Access Compliance Report

Public Rights-of-Way

Intersection ID: N/A	Main Street: SUTHER_RD	Cross Street: SANDBURG_AV	Location: N
ADA ID: 1C833B47E10F	Ramp Type: PerpDiag	Initial Pass/Fail: Pass	Overall Compliance: No
		Severity Score: 0.25

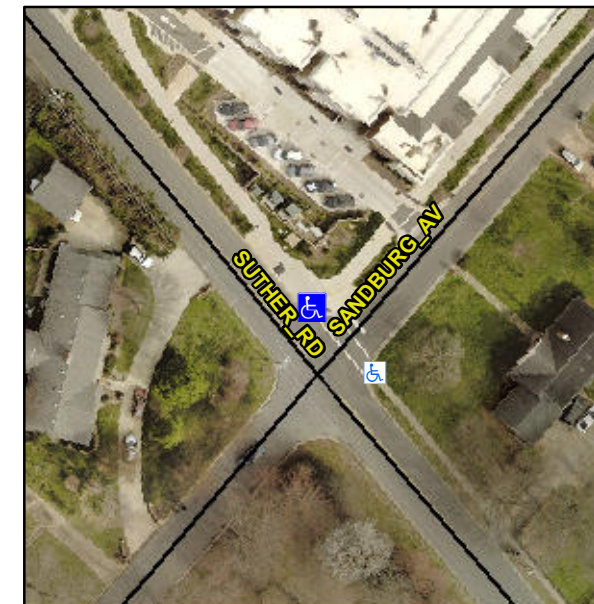
Codes/Mitigation Info/Possible Solution

R304.5.3, R305.2

Compliance	Description	Data	Compliance	Description	Data
N/A	Ramp Length (in)	94.0	Yes	Ramp Slope (%)	5.6
Yes	Ramp Width (in)	48.0	No	Ramp XSlope (%)	4.0
N/A	Flare Type LT	Sloped	N/A	Flare Type RT	N/A
N/A	Flare Slope LT (%)	8.1	Yes	Flare Slope RT (%)	1.5
N/A	Flare Traversable LT?	Yes	N/A	Flare Traversable RT?	Yes
Yes	Landing Length (in)	60.0	Yes	DWS Provided?	Yes
Yes	Landing Width (in)	60.0	Yes	DWS Contrast?	Yes
Yes	Landing Slope (%)	1.8	Yes	DWS Length (in)	24.0
No	Landing X Slope (%)	3.2	Yes	DWS Full Width?	Yes
N/A	Landing Curb? (Y/N)	No	No	DWS Offset (in)	3.0
N/A	Shared Landing?	No			
Yes	Gutter Ponding?	No	Yes	Gutter Slope (%)	1.5
Yes	Gutter Lip Ht (in)	0.0	No	Gutter X Slope (%)	4.0
N/A	Painted X Walk1?	No	N/A	Painted X Walk2?	Yes
	X Walk 1 Direction	To SW		X Walk 2 Direction	To SE
N/A	X Walk 1 Width (in)	N/A	N/A	X Walk 2 Width (in)	88.5
	X Walk 1 Slope (%)	4.6		X Walk 2 Slope (%)	0.9
	X Walk 1 X Slope (%)	1.0		X Walk 2 X Slope (%)	4.5

Remove & Replace Curb Ramp With Two New Directional Ramps or Equivalent. Remove & Replace Gutter.
